NW Energy Coalition
Comments on and Requests
regarding the PSE 2021 IRP Webinar #5:
Social Cost of Carbon, July 21st, 2020

July 24, 2020

Social cost of carbon as a cost adder

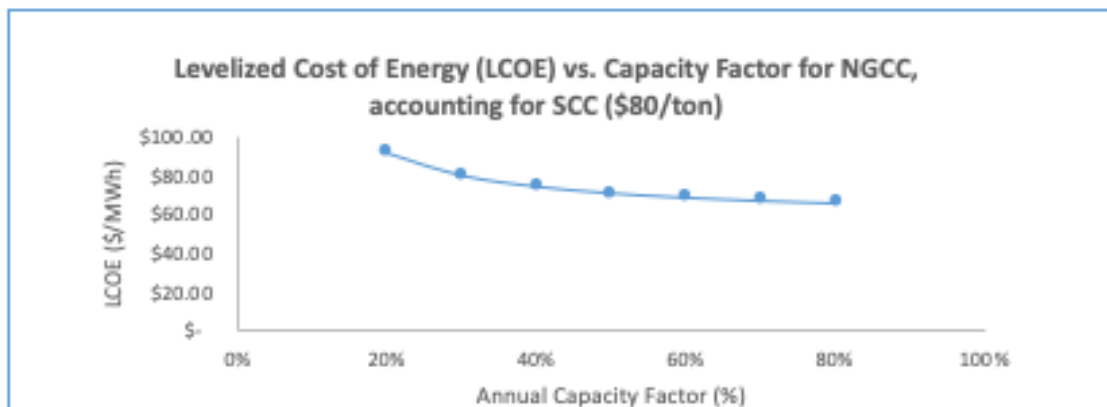
a NGCC's capacity factor (all else being equal), which will increase overall cost on a levelized basis. On a per MWh basis, including the SCC in only the investment analysis and not in modeled dispatch will skew the economics of two identical resources. This is illustrated by using the chart PSE provided on Slide 20;

Treating SCC as a fixed cost may raise the capital cost of the certain thermal resources, but may well lower levelized costs (a per MWh measure). The model’s economic “incentive” is to add thermals and run them more because they become more economic the more they run, as their upfront fixed cost is spread over more and more MWhs. By excluding SCC from dispatch modeling, it is more likely that certain new and existing thermal resources will *run more* than if the SCC was accounted for in their dispatch costs

As a result, the incorrect price signal is being sent to the model, especially when selecting against demand-side resources. Consequently, there will be no way to test if higher amounts of demand-side resources will result in a lower cost/lower risk portfolio.

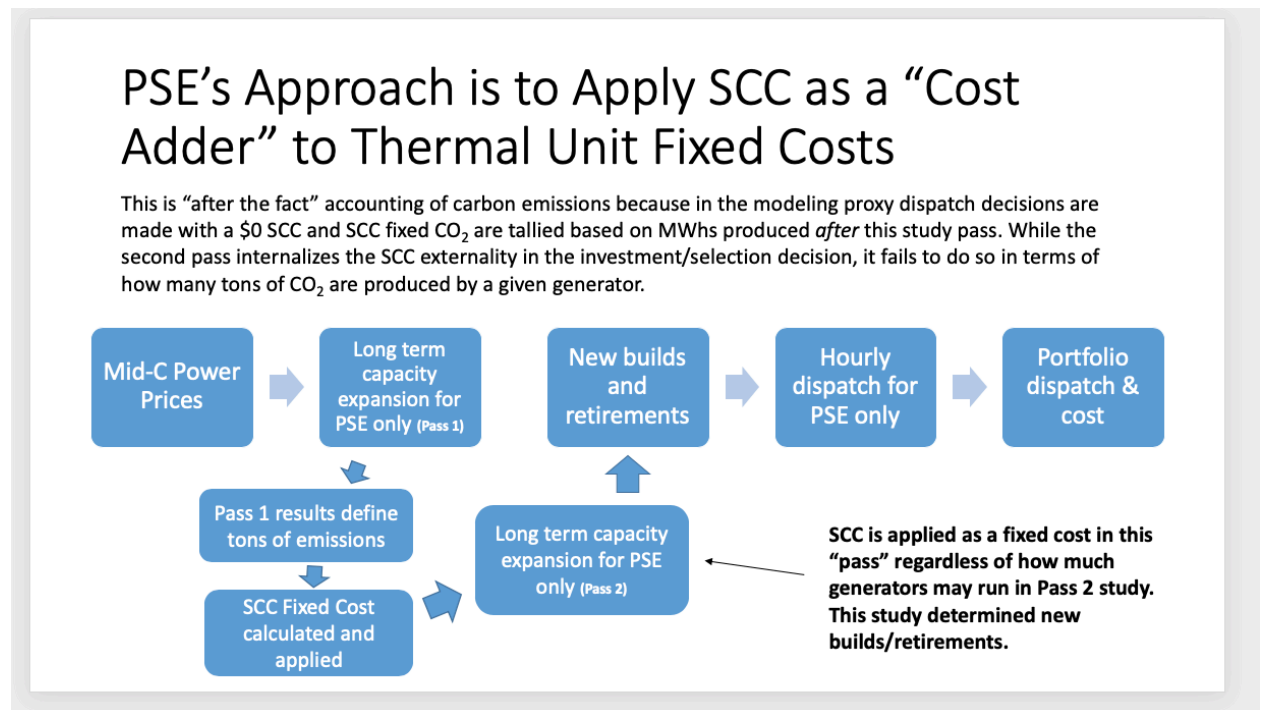
PSE’s agreement to run a scenario incorporating the SCC in dispatch will allow a comparison between treating SCC as a fixed cost and treating SCC as a variable cost to see if that makes a difference in the resources chosen for the portfolio. This is how we understand PSE’s proposal:

An Alternative Approach is to Apply SCC as a Cost Adder to the Variable Cost of Thermal Generators

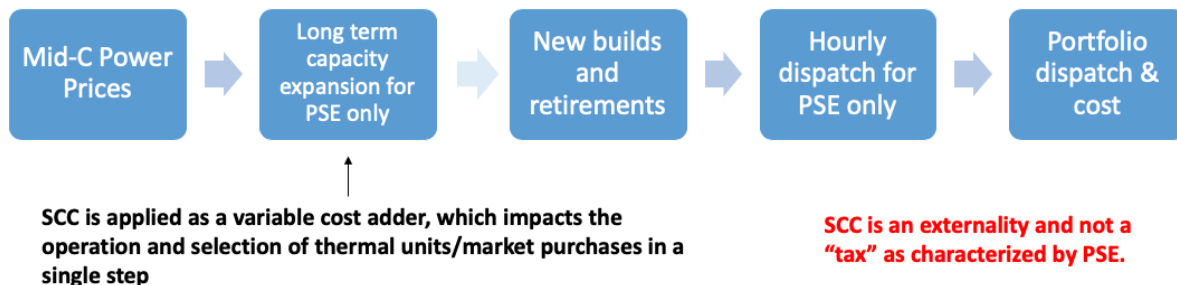
We suggest the following as an alternative to the methodology depicted in Slide 21:

This approach allows the externality (SCC) to be internalized into the operational and investment decision of the generator or power purchase. Incorporating the cost of the externality – carbon emissions – based on the SCC will cause a dispatch that relies on thermal generation less and makes thermal generation more expensive. A high variable cost and low(er) generator output means a thermal unit will have more difficulty recovering its fixed capital costs, which are unchanged. This fully internalizes the SCC externality.
